1970 - 1973 Corvette: Service Bulletin: Engine Overheat

Model and Year: 1970 - 1973 Corvettes with 454 Cu. In. Engines and Air Conditioning

Bulletin Number: 73-T-28, Section VI

Date: May 14, 1973

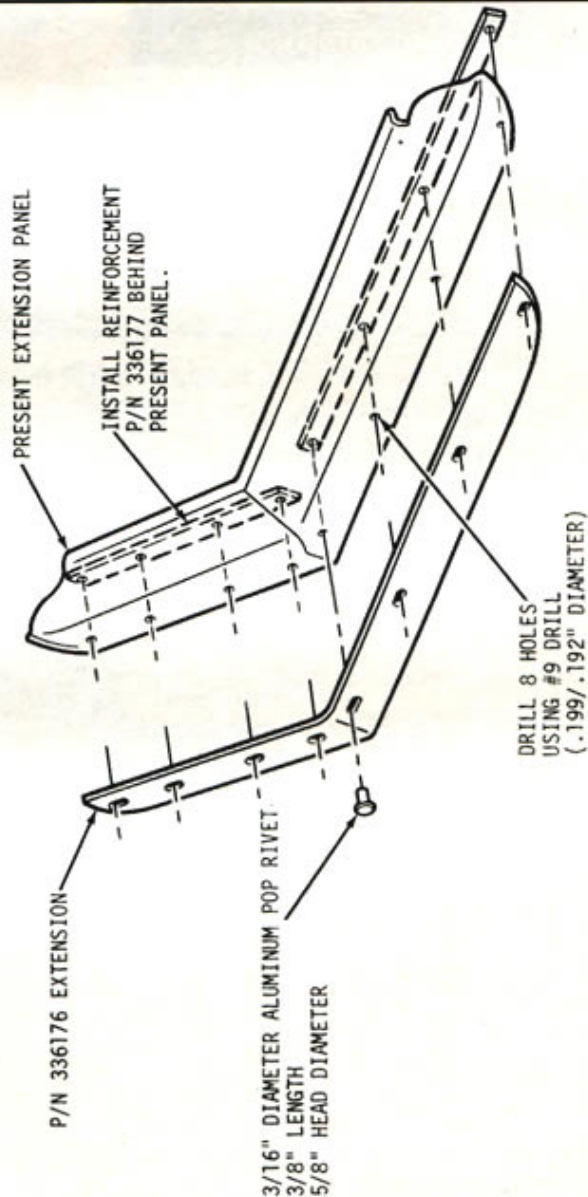
To improve low speed cooling, an additional grille panel lower extension was installed in 1973 Corvettes produced after Vehicle Identification Number 1Z37Z3S410722. This extension, Part Number 336176, may be installed as illustrated on page 2 of this bulletin on early 1973 Corvettes only .
